Dixie-Narco®

Service Bulletin # Date: October 1, 1984 Revised: ~~May 8, 1985~~

MODEL: DNTP 232-8

SUBJECT: Inner Liner (Kydex)
For Package Chute

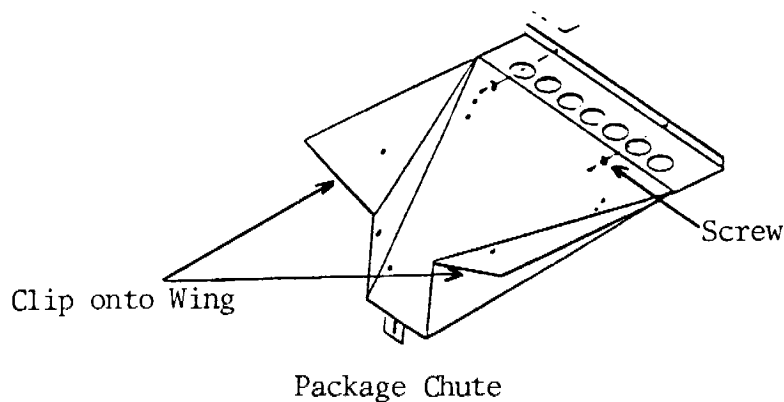
REASON: Due to "slide" characteristic differences between packages an inner liner (Kydex) is provided which increases the package's acceleration as it slides down the chute.

1. Secure inner liner with existing chute screws at inside rear of cabinet.
2. Use clips to secure inner liner to chute wings at front.
